American Telecommunications Certification Body Inc.
6731 Whittier Ave, McLean, VA 22101

RE: Visonic Ltd.

FCC ID: GSAPWRMAXPRO

After a review of the submitted information, I have a few comments on the above referenced Application.

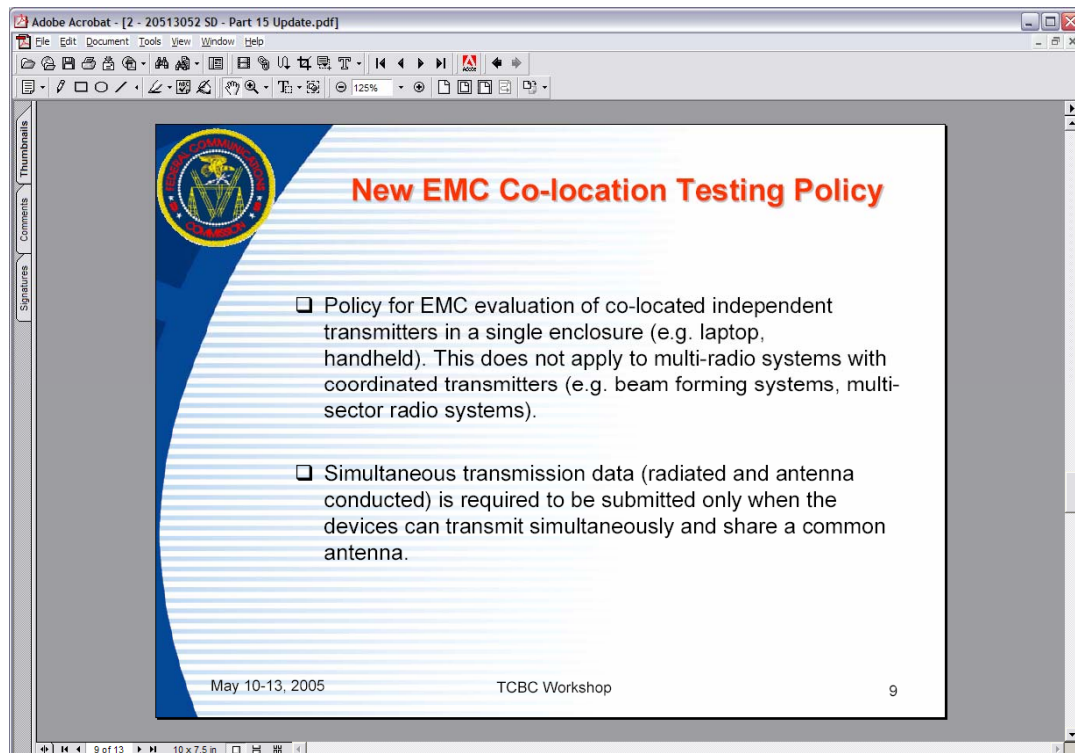
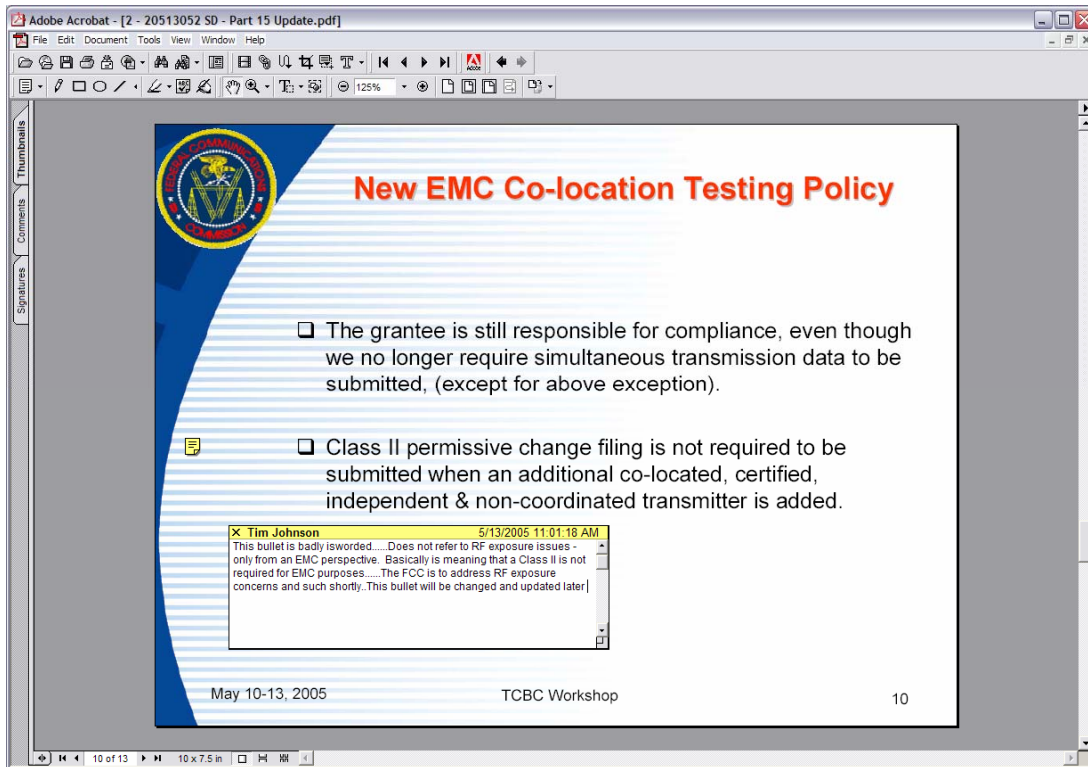
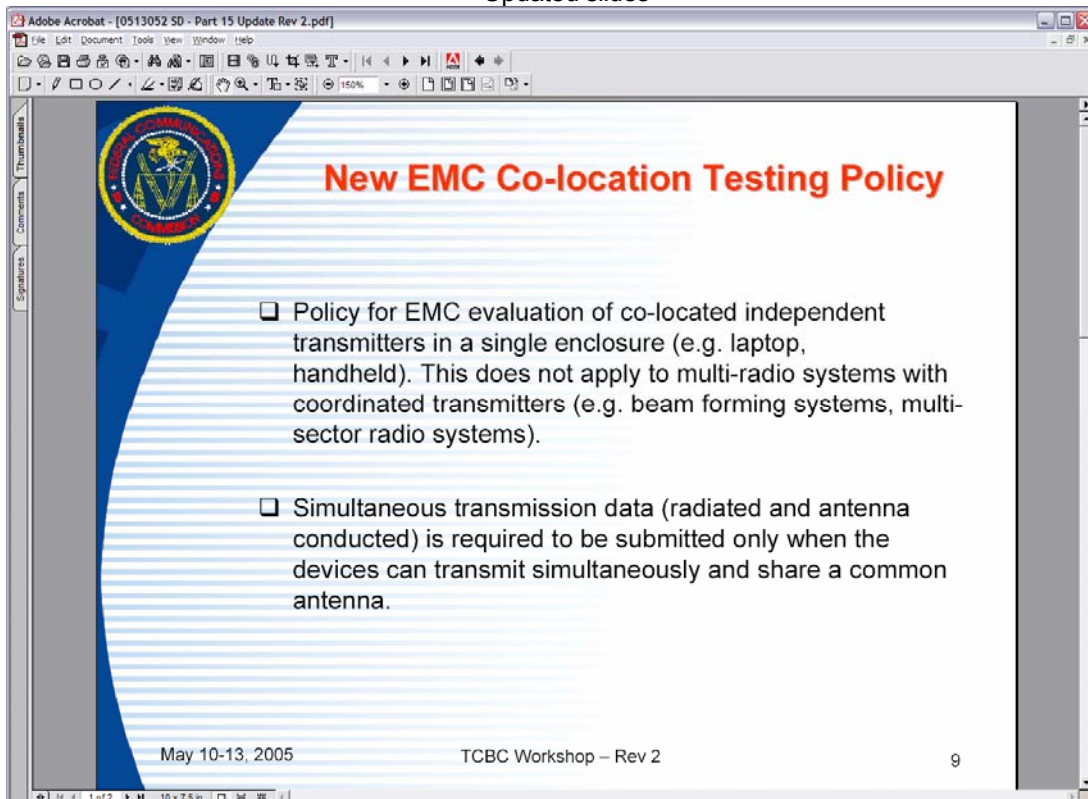
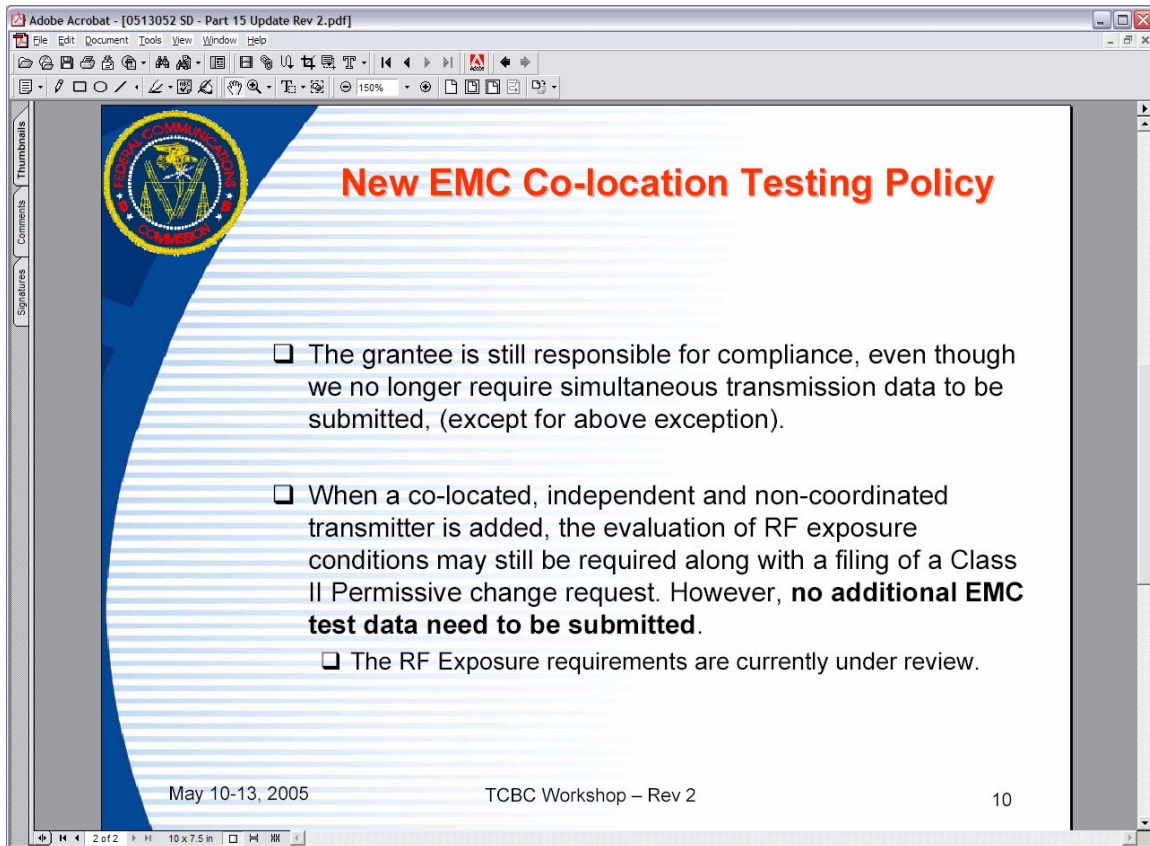
- 2) Regarding co-location, please provide specific information as to where this information is provided or found (specific training, dates and pages, and/or KDB reference numbers, etc.). Please note that the co-located discussion (in EMC) was poorly worded and created much discussion during training. Further updated slides were released at a later date to help clarify this concern. Note that May training in 2005 clarified that the FCC no longer required EMC co-location testing to be provided unless requested by the FCC. However this did NOT eliminate the fact that it must still be investigated and found to be compliant. Also, the training only clarified that it was no longer necessary to include this in applications to the FCC. Additionally, this fact is ONLY relevant to the EMC co-location and does not address RF co-location issues. RF co-location still followed all specified guidelines. Current information (released January 2006) clearly shows that co-location must be handled in ALL associated applications. Please see below slides and attach exhibits for further information.
